Access Compliance Report Public Rights-of-Way (Curb Ramps)

Main Street: HAZARD_AVE Cross Street: WILSON_ST Location: NW

ADA ID: RPRK220203113322 Ramp Type: Type 4 - Parallel Initial Pass/Fail: Fail Overall Compliance: No Severity Score: 2

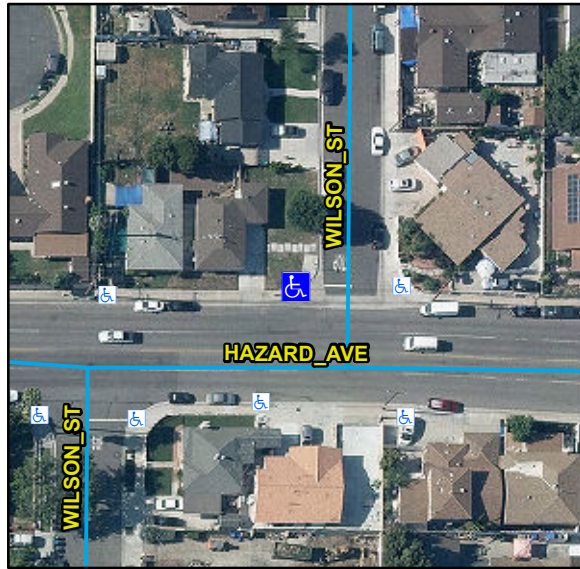
R304.5.3, STD 1115

Compliance	Description	Data	Compliance	Description	Data
N/A	Ramp Length LT (in)	106	N/A	Ramp Length RT (in)	109
Yes	Ramp Width LT (in)	59	Yes	Ramp Width RT (in)	59
Yes	Ramp Run Slope LT (%)	7.3	Yes	Ramp Run Slope RT (%)	7.8
No	Ramp Cross Slope LT (%)	2.5	Yes	Ramp Cross Slope RT (%)	0.3
N/A	Landing Present	N/A	N/A	DWS Provided	N/A
N/A	Landing Length (in)	N/A	N/A	DWS Contrast	N/A
N/A	Landing Width (in)	N/A	N/A	DWS Length (in)	N/A
N/A	Landing Run Slope (%)	N/A	N/A	DWS Full Width	N/A
N/A	Landing Cross Slope (%)	N/A		DWS Offset Type	N/A
N/A	Landing Movement Obstructed?	N/A	N/A	DWS Offset Left (in)	N/A
	Landing Movement Type	N/A	N/A	DWS Offset Right (in)	N/A
N/A	Landing Shared	N/A			
N/A	Clear Space	Yes			
N/A	Clear Space To Crosswalk (in)	N/A			
N/A	Marked Crosswalk 1	No	N/A	Marked Crosswalk 2	No
	Crossing 1 Direction	S		Crossing 2 Direction	E
	Marked Crosswalk 1 Width (in)	N/A		Marked Crosswalk 2 Width (in)	N/A

Remove & Replace Curb Ramp With Two New Directional Ramps or Equivalent.
